**Origination Form**  
Proposed Revisions to a Standard Plans Index

<b>Originator:</b>	Turley, Joshua	<b>Index Number:</b>	455-060
<b>Date:</b>	5/15/2025	<b>Sheet Number(s):</b>	Sheet 1
<b>E-mail:</b>	Joshua.Turley@dot.state.fl.us	<b>Index Title:</b>	60" PRESTRESSED CONCRETE CYLINDER PILE

ELEVATION

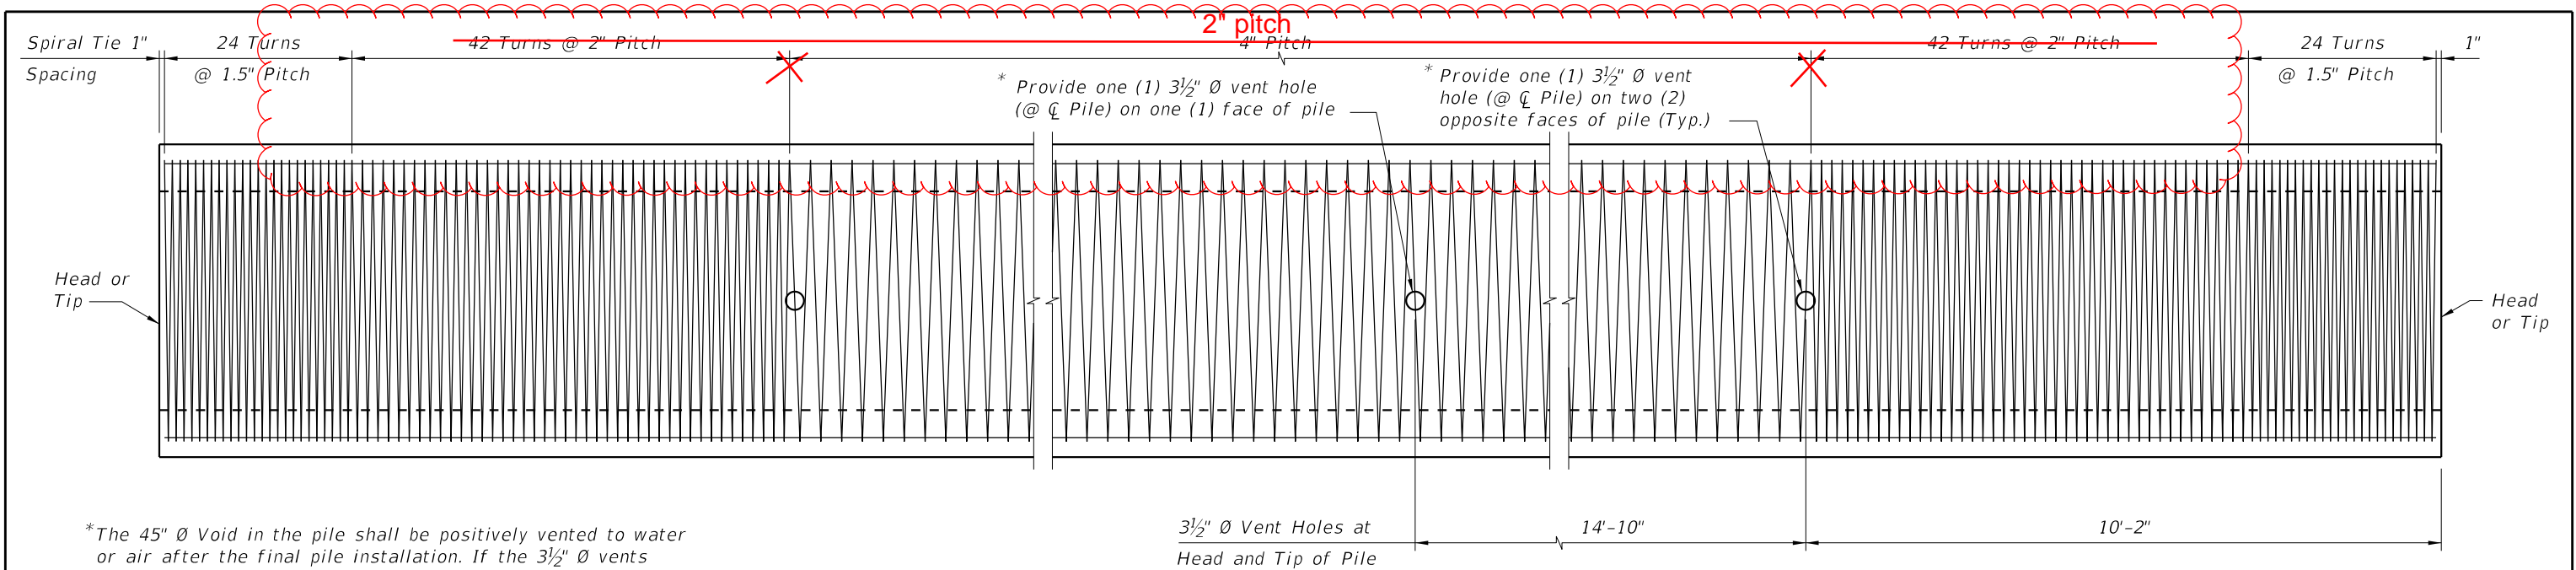
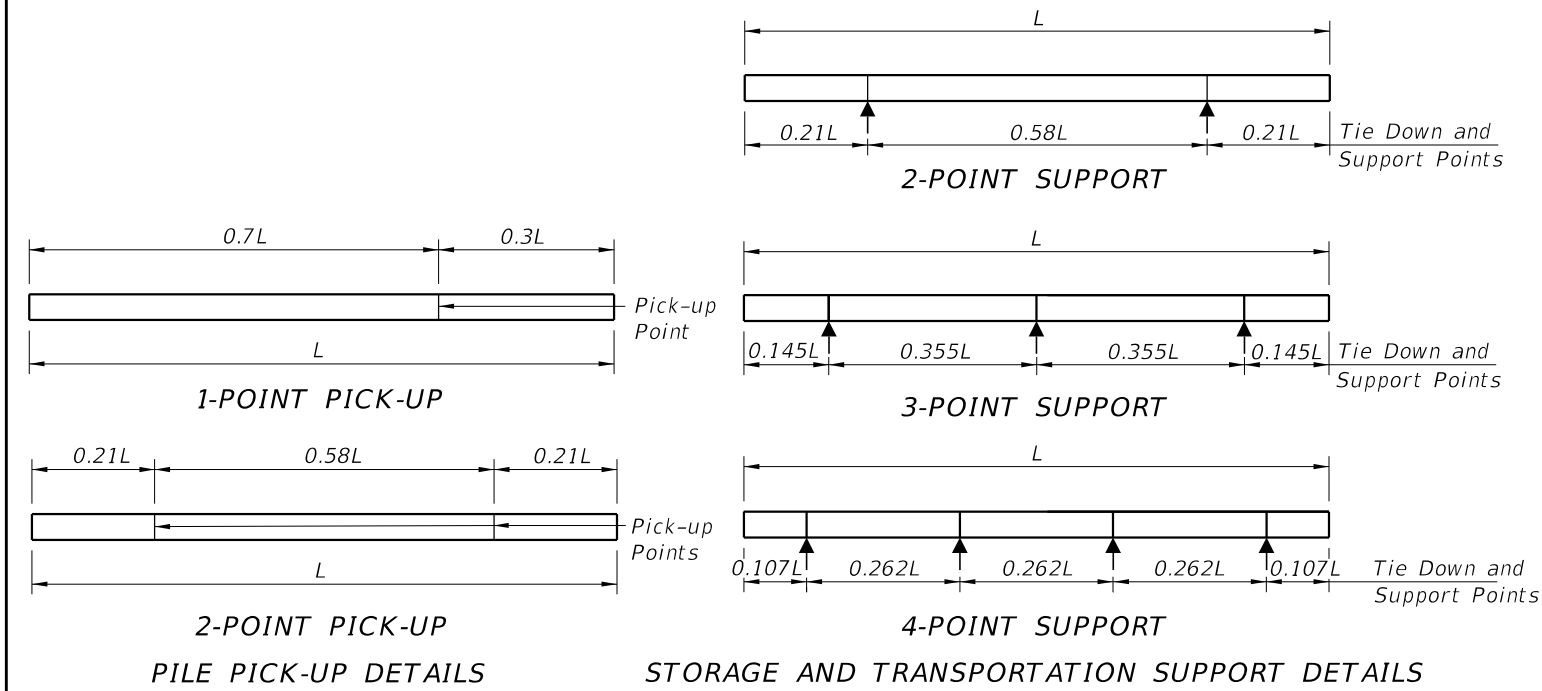
Sheet 1: Changed the pitch spacing of the stirrups in the ELEVATION.

Vertical cracking has been observed in hollow core prestressed concrete piles, including 30-in. voided square HMC and conventional piles, and 60-in. hollow cylindrical piles, during installation and service. To address cracks frequently occur within the 4" stirrup pitch zone, a reduction in stirrup pitch to 2" is proposed to help mitigate cracking in these areas.
